AGENDA
CITY OF ORMOND BEACH, FLORIDA
CITY COMMISSION MEETING
May 4, 2021
7:00 PM

- B. ORDINANCE NO. 2021-17:** AN ORDINANCE APPROVING A PLANNED BUSINESS DEVELOPMENT TO BE KNOWN AS "ORMOND ACE HARDWARE" TO BE LOCATED AT 1480 NORTH U.S. HIGHWAY 1; AUTHORIZING THE EXECUTION AND ISSUANCE OF A DEVELOPMENT ORDER THEREFORE; AUTHORIZING THE CONSTRUCTION OF A TWO-STORY RETAIL USE BUILDING AND GARDEN CENTER; AUTHORIZING OUTDOOR ACTIVITY USE, REDUCTION OF SETBACKS, AND ASSOCIATED SITE IMPROVEMENTS; ESTABLISHING CONDITIONS AND EXPIRATIONS OF APPROVAL; AND SETTING FORTH AN EFFECTIVE DATE. **(SECOND READING)**

This is a request from Gross Family Properties NG, LLC, property owner, for a zoning map amendment of the property at 1480 North U.S. Highway 1 from B-7 (Highway Tourist Commercial) to PBD (Planned Business Development). The zoning map amendment location is shown in Exhibit 1 below.

EXHIBIT 3: February 5, 2021 submittal:

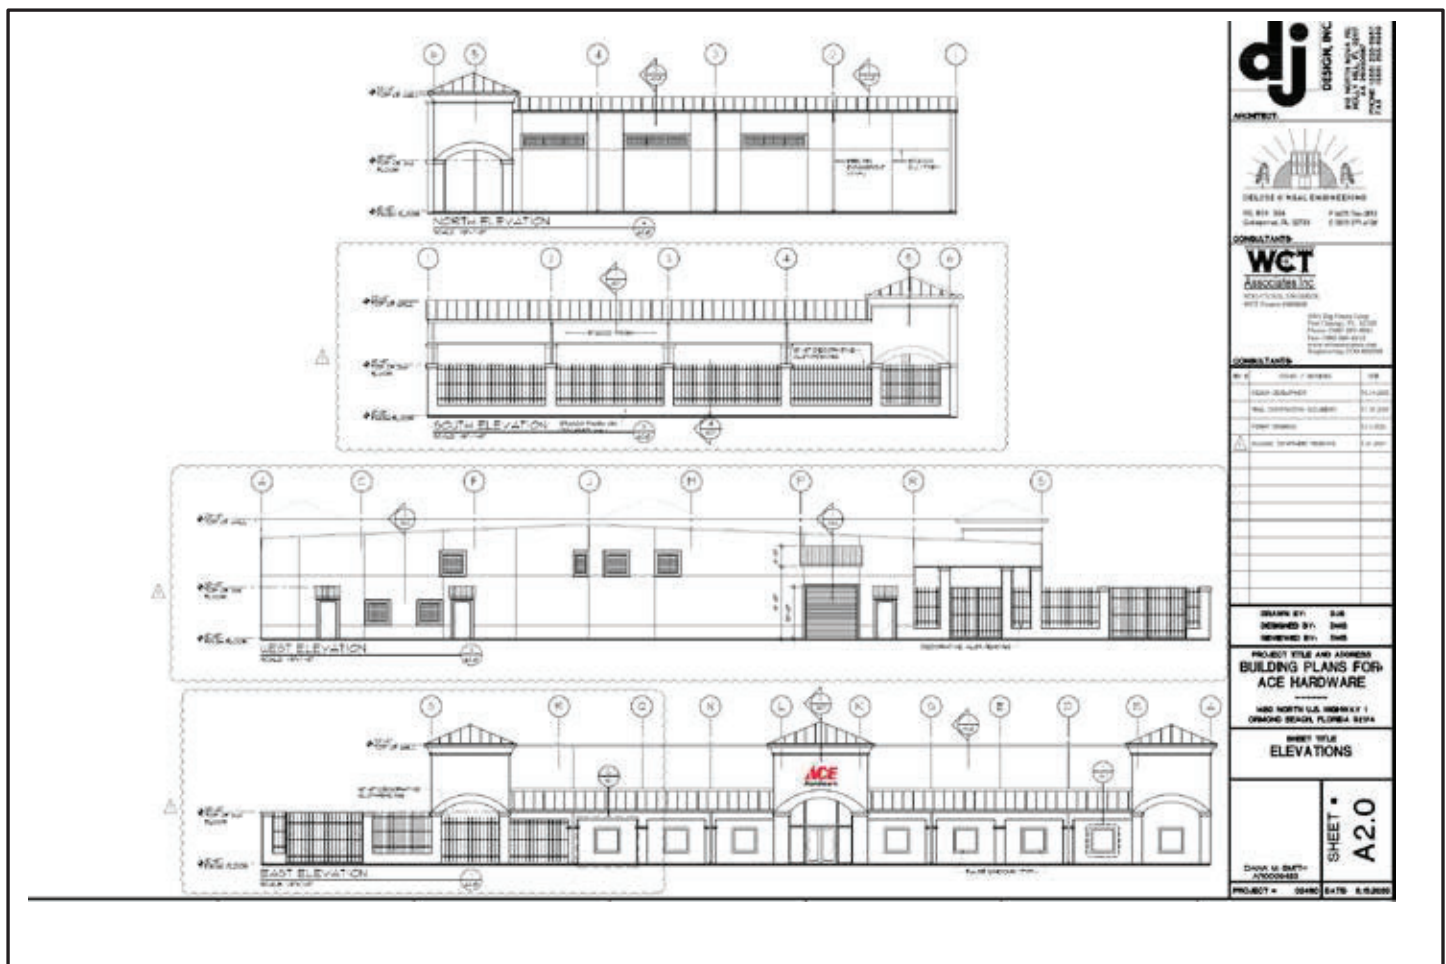
Mr. Spraker discussed the fourth item, regarding the rear façade of the building. He stated the original submittal for the building included a stucco finish, but explained the applicant was now requesting metal panels on the rear of the building. He noted the Planning Board recommended approval of the metal panels, and staff changed their recommendation of the stucco finish to pick up the Planning Board’s recommendation.

Commissioner Selby questioned why staff’s original recommendation was to finish the rear façade with stucco and not allow metal panels; whereby, Mr. Spraker stated the Land Development Code (LDC) had specific standards which required a finished façade, and noted there would be individuals who would see the back of the building while traveling on nearby roads.

With the site plan submittal of February 5, 2021, the applicant provided an architectural plan that utilized the Neo-Eclectic architectural style. The Site Plan Review Committee had no comments on the architectural elevation, shown below:

EXHIBIT 4: February 26, 2021 Planned Business Development submittal:

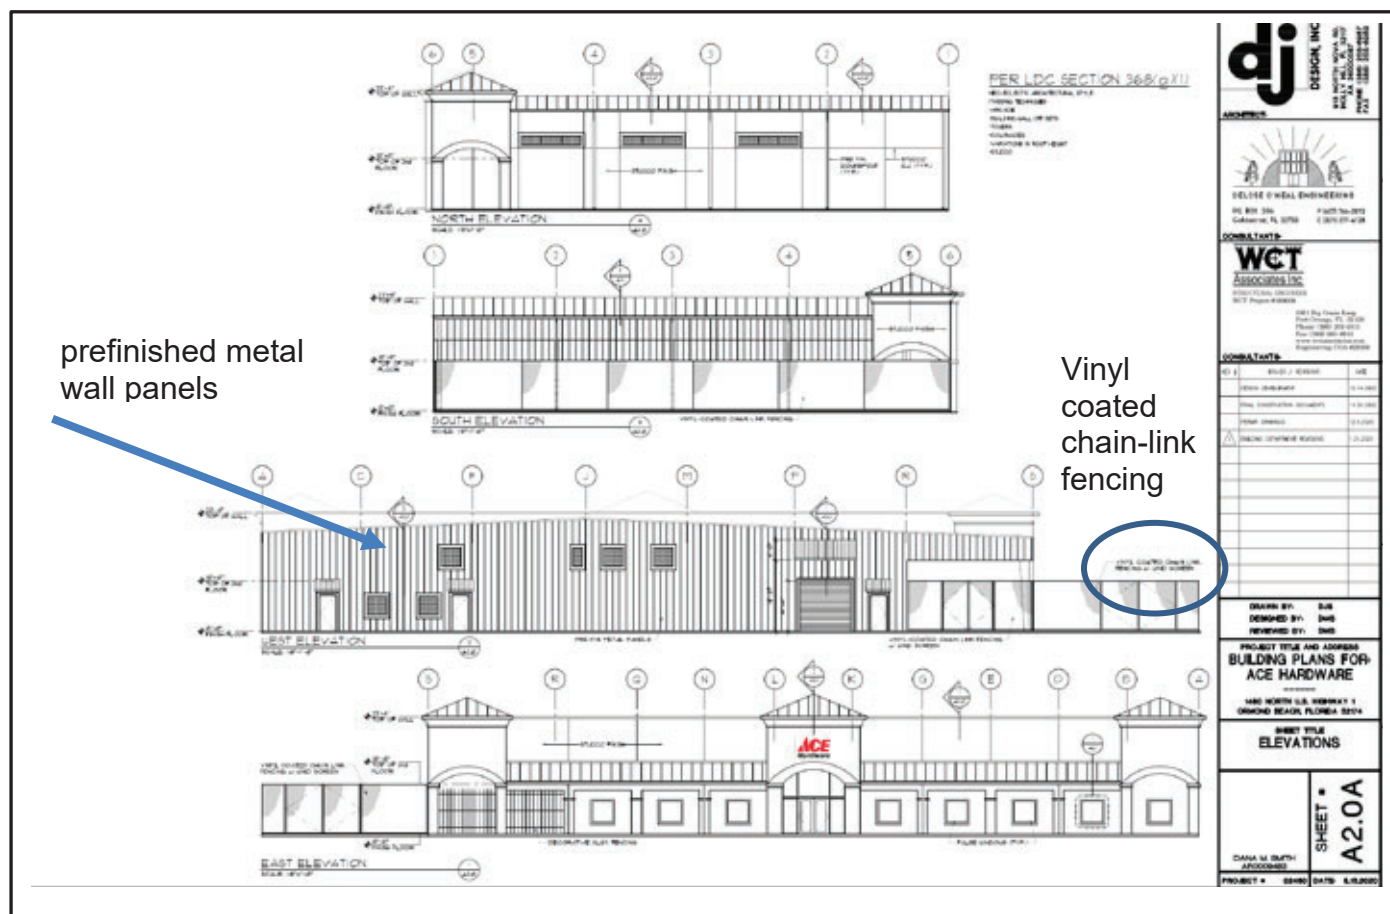
Mr. Spraker proceeded to discuss fencing around the Garden Center. He noted the applicant was seeking to allow a ten-foot, black, chain-link fence with black mesh. He stated the Planning Board had a tie-vote on allowing the chain-link fencing and did not come up with a final recommendation. He noted the applicant had requested chain-link fencing for the rear of the property when the item was presented at the Planning Board Meeting. He explained the ordinance before the Commission was written to approve of the first three items, to allow metal panels on the rear façade, and to require decorative aluminum fencing.

With the Planned Business Development application and letter submitted February 22, 2021 there was a modification to the proposed architectural elevations. The letter sought to allow prefinished metal wall panels on the rear façade facing the retention pond. Staff requested a building elevation that described the requested change in the building façade. The project architect provided the following architectural elevation:

Section 3-68(4)(e) of the Land Development Code states, “The use of chain-link fencing shall only be permitted for properties in the I-1 zoning district, provided the property is not located on an arterial or collector street”. Similar to the prefinished metal wall panels on the rear façade, the fence material was revised between the February 5, 2021 submittal (Exhibit 3 above) and the February 26, 2021 Planned Business Development submittal (Exhibit 4 above).

Mayor Partington confirmed the motion required decorative, aluminum fencing on the front, and chain-link fencing with black mesh along the side and back. He questioned if staff needed any further direction; whereby, Mr. Spraker stated the motion provided the requested information.

SHEET #
A0.1

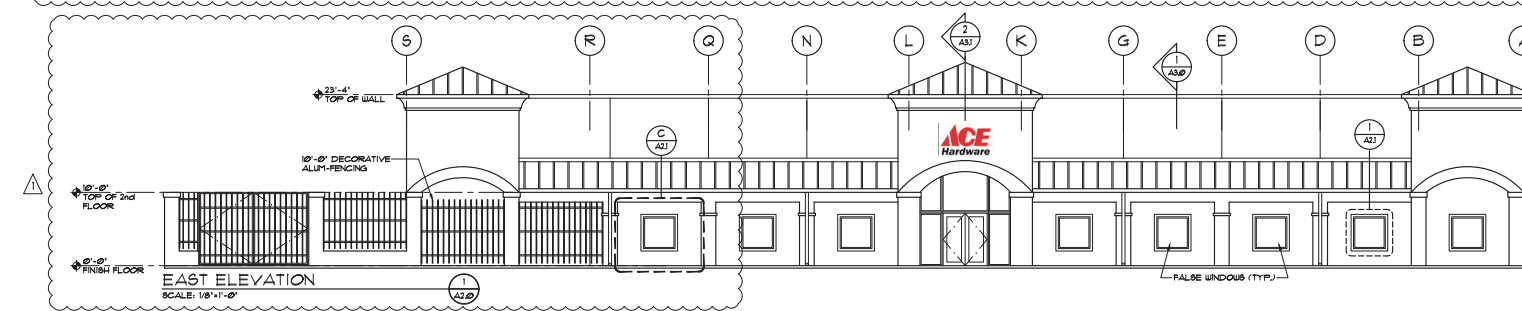
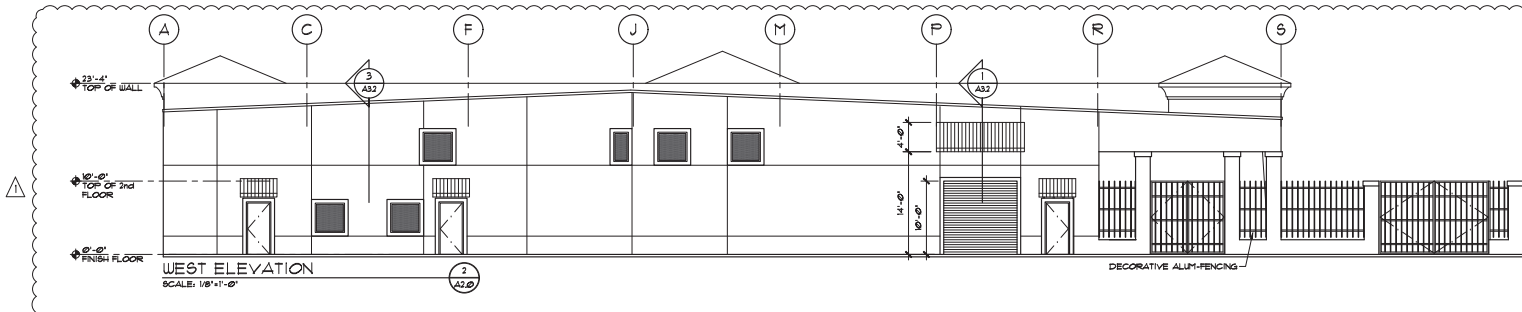
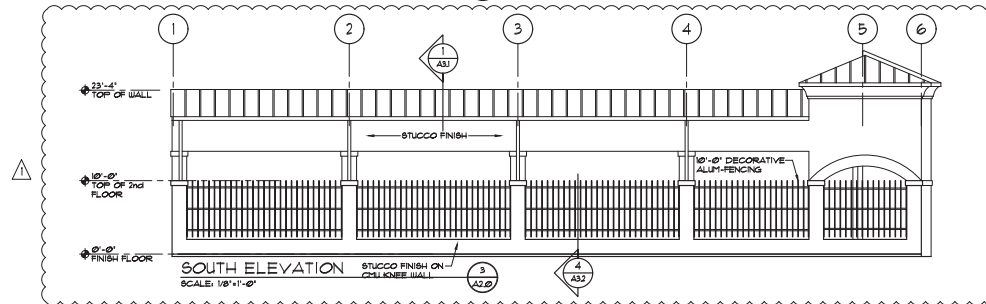
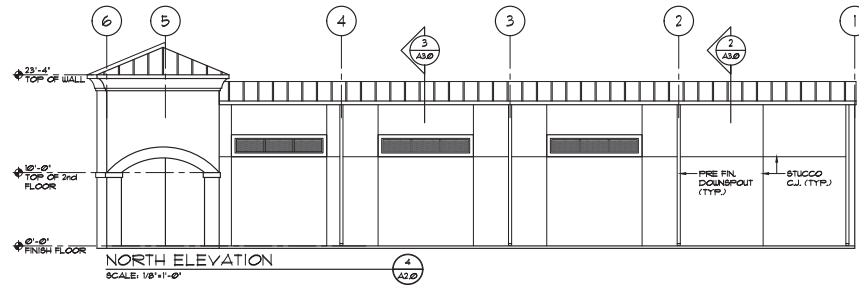
| 2 | Planning Director | <p>File: A0.1.pdf</p> <p>ChangeMark: SSS</p> <p>Description: Planning, digital signatures</p> <p>Comment: All drawings and technical documents that need to be signed and sealed by a licensed design professional must be done so using a Digital Signature that contains a Public Key Certificate issued through a 3rd Party Certification Authority. This "Authority" is a commercial service paid for by the design professional to verify their identity through various methods and then issues a security certificate that contains both a Private Key that is password protected by the design professional and a public key that allows the recipient to download and view the certificate. Please provide the digital signature for this drawing. Electronic Signature Required. Survey shall be signed, dated and sealed and certified to the city in accordance with Section 4-06(4)b. of the Land Development Code. All drawings and technical documents that need to be signed and sealed by a licensed design professional must be done so using a Digital Signature that contains a Public Key Certificate issued through a 3rd Party Certification Authority. This "Authority" is a commercial service paid for by the design professional to verify their identity through various methods and then issues a security certificate that contains both a Private Key that is password protected by the design professional and a public key that allows the recipient to download and view the certificate. Please provide the digital signature for all architectural sheets submitted.</p> |  |
